MEADOW LAKE APARTMENTS- 100% DOCUMENT BID PACKAGE <u>ADDENDUM NO. 0 2</u>

Date: 4/30/2024

Meadowlake Apartments Bid Package #2 100% CD Drawing Review Comments Drawings Dated: 3-18-2024

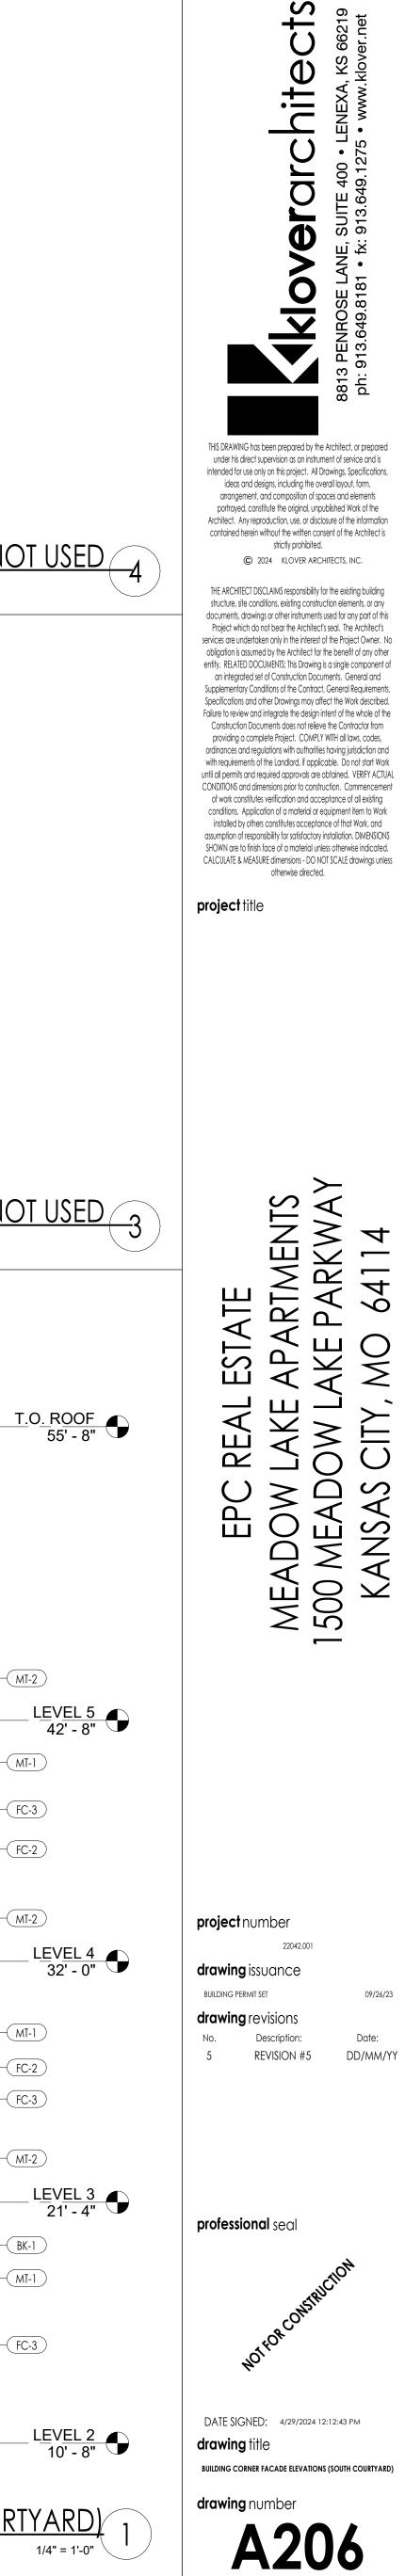
Dia	wings Dated					Open/
No.	Sheet No.	Question By	Bidder Question	Answer	Ball in Court	Closed
1			1. I see the Unit Plumbing Fixture Schedule on Plan U002 but the plans for the units do not reflect the Fixture labels on the Plumbing plans. Is there another sheet I am missing?	The MEP Sheets should be referenced for the sinks and faucets. I have marked up the Unit Plumbing Fixture Schedule on Sheet U002 to replace incorrectly shown tub bases and added a roll-in shower pan that should be used at the Type A Units. Also added the plumbing tags to the shower fixtures for clarification - please see the attached Unit Plumbing Markups.		
2				Follow the items listed in the Plumbing Fixture Schedule on Sheet ME301.		
3				Sump Pump Schedule can be found on Sheet ME301.		
4			In the existing building, the Drawings call for a 90° ceiling typically, but does not specify what framing method to achieve that height (or even that the material is sheetrock). What is the desired design? Do you want us to provide an option for us to install a drywall suspension system at all "Office" type units in the existing building?	The existing concrete ceiling is to be exposed except in the bathrooms or where there is a "pancake" HVAC unit in the entryway. The OFF-MS3 Unit Type will have a 9'-0" gyp. board ceiling throughout the unit.

5			I found a stained concrete spec in Meadow Lakes but cannot find where it applies. Is there stained concrete on this project?	No stained concrete currently but this spec section remains since the interior design finishes for the amenity spaces have not been finalized.		
6			panel is or is this just an oversized roof cap?	The MT-1 is tagged to the parapet caps on the elevations. Spec Section 07 60 00 Flashing & Sheet Metal specifies the thickness as 0.050 inch thick.		
7			2. No fiber cement trim is shown around windows, doors, corners, etc. Are the windows and doors trimmed out?	The Fiber Cement Spec Section (07 46 00 - Subsection 2.4 Accessories) calls out for corner posts, door/window casings, moldings and trims.		
8	A125		Sheet A125 doesn't show any designations for the extent of the drywall plenum in the garage. Does the entire garage receive a drywall plenum?	On Sheet A125, the garage plenum is shown under the Unit footprint from above. The plenum edge is shown on this sheet. There are straight lines with 90 degree corners indicating where the plenum will be located.

— 1	1		The emerities are included with the	
		The following Note is an multiple pages. Discos statify whether an act the Ameritian are to be included in this	The amenities are included with the project. This note was added for	
		······································	project. This note was added for permitting letting the city know that the	
			work in the amenity areas would be	
			submitted separately from the main plan	
9	Multiple		set.	
9	Siding		Set.	
10	Questions	1. Please confirm that all products are to be primed and ready to paint.	Correct	
			The lap sizing will be as follows: Deep	
		2 Specifications are unclear on the lan reveal size, please provide lan sizing. Three different sidings are	Ocean - 6.25" / Arctic White - 8.25" /	
		called for will all be the same lan size?	Pearl Gray - 6.25". This is not reflected	
			on the plans currently but will be added	
11			with the next revision.

3. There is only one piece of trim called out on the plan set (trim over the balcony overhang). Please confirm	The Fiber Cement Spec Section (07 46	
		no trims at any openings. Per Hardie manufacturing warranty guidelines a single inside corner trim and double	00 - Subsection 2.4 Accessories) calls	
12		outside corper trim will be required	out for corner posts, door/window	
12			casings, moldings and trims.	
			Why can't hardie or other fiber cement panels be installed flat against framing?	
			What is the alternative for wrapping	
13			balconies with a fiber cement material?	
14			Correct.	
15		6. Item 9.71 on page A350 is only available in Australia and not the united states.	This will be removed.	
			Exterior gyp. with skim coat at exterior

7. RCP plan only identifies a few exterior ceilings, can an updated set of plans be provided to help identify	pergola structures, soffits of balconies to	
		where each ceiling product is located?	be wood grain hardie board. Drawings	
			will be updated to show the finish at the	
16			proper locations on the RCPs.	
			Elevations of the corner facades have	
47		clear understanding at each of the three locations?	been added to new Sheets A206 and	
17			A207. These sheets are included.	
			The Roller Window Shades Spec	
	Finish		Section (12 24 13 - Subsection 2.1 Materials) calls out for roller shades to	
	Legend		be installed at all windows and glass	
	Legenu		doors (including transoms) in the	
18			Common Areas and Apartments.	
19				
20				
21				
22				
23				
24				
25	1			
26				
27				
28				
29				
30				
31				
32				
33				
34				
35
